NOTE FOR VERSION CHANGE:

CABLE P/N: 4260518-01

INVERTER CABLE PHR5/XHP-4,5, 300mm

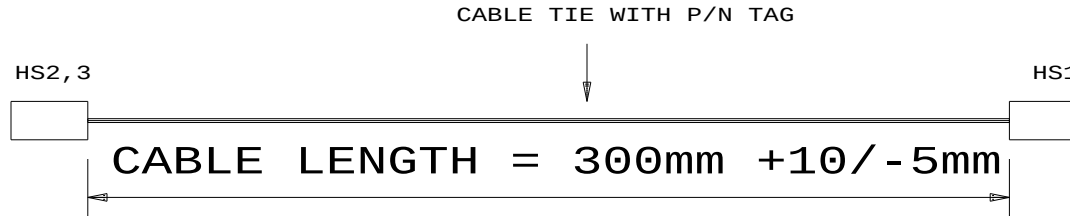
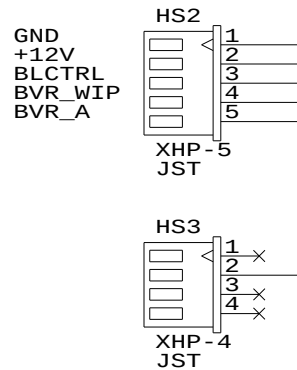
- CORRECTED CONNECTORS REFERENCE NAME
- CHANGED HS2.5 TO HS3.2 WIRE LENGTH TO 60mm
- STATED HS1 MUST USE JST

- * CN1: MUST USE JST PHR-5 CONNECTOR (NO COMPATIBLE)
- CN2 AND 3: CAN BE COMPATIBLE PART
